## MAPLE & POPLAR

### NHBC Cantilever Balcony Design Timeline

#### TYPICAL BALCONY TO SLAB DETAIL

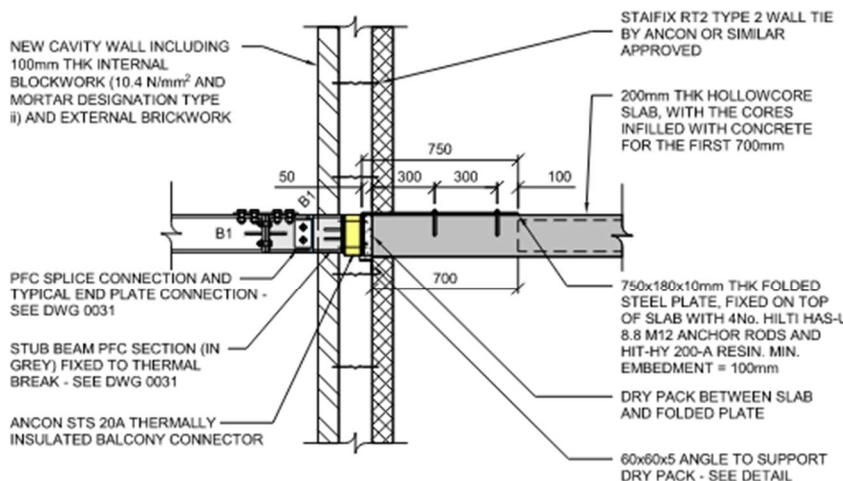
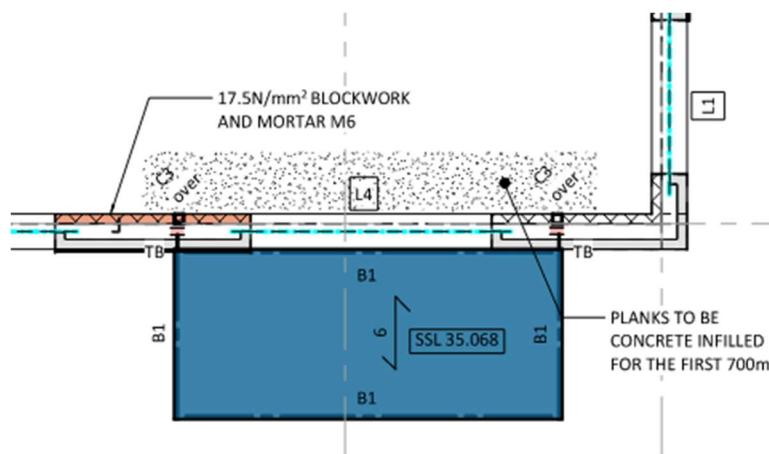
This design was based on the precast slabs being solid in the location of the balconies onto which the back cantilever span of the balcony steels was bolted, as can be seen in the below 2 screenshots.

Building Control carried out their checks and signed off the design but NHBC raised various queries, the balconies being one of these. Since these initial NHBC comments there has been continuous back

It has ended up with NHBC not wanting to warrant the design as is, even though it has been proved to work by calculation they believe there still to be a risk. They have said they have had various claims recently on balconies so are reviewing these in detail now. Please note these schemes with NHBC balcony issues were not Neilcott.

#### Option 1 – Clamping of Precast Slab

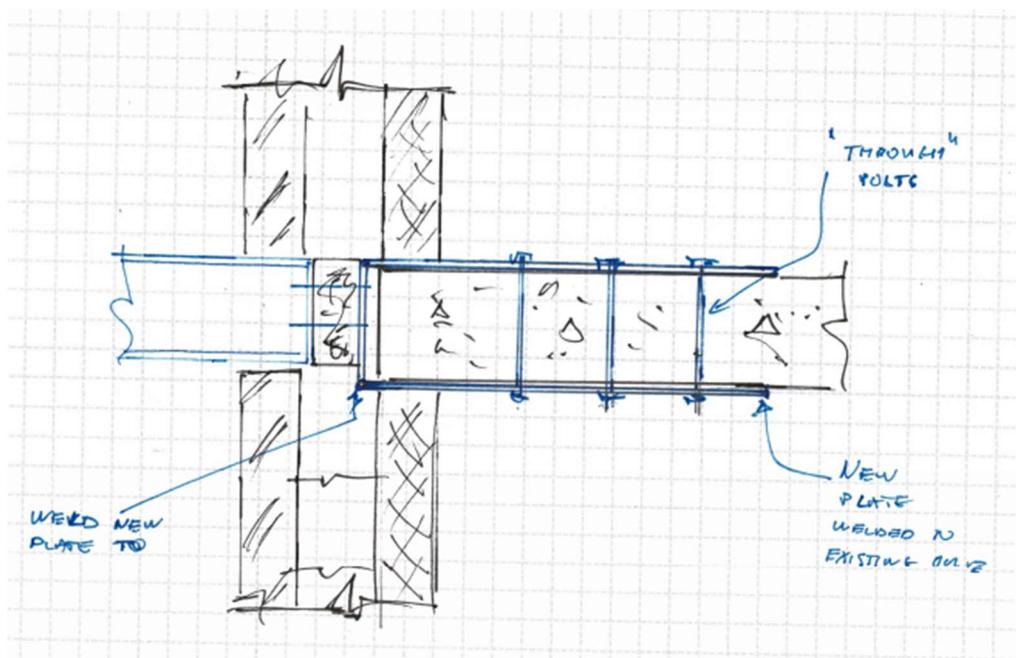
The details here would have been to open up the soffit below each affected balcony position and install a plate beneath the one already installed and then resin bolt this up to the soffit (slightly different from below screenshot which shows bolts going right through slab). We would also have had to open up the external block and brickwork to weld this onto the exiting plate.

NHBC reviewed this option and although again it structural worked, as it was unconventional they would not approve this design option.

## Option 2 – External Columns Tight to Brickwork

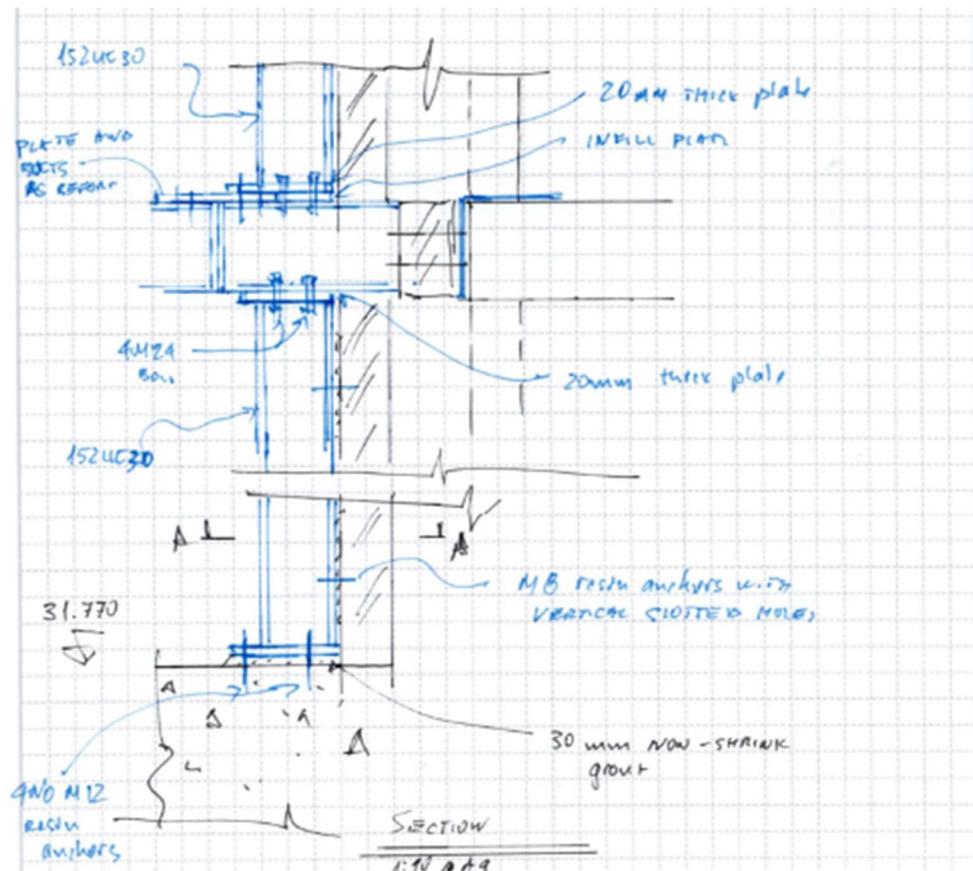
This design introduced new steel columns up against the external brickwork to eradicate the forces of concern by the NHBC. This design by its nature would change the external appearance of the building , hence why it was our second option.

Below is screenshot of the connection design, and below that marked up elevations of where the posts would be on the South Block.

Unfortunately again although the NHBC engineers liked the out the box proposal and could be proven to work, they would not accept this as it was unconventional.
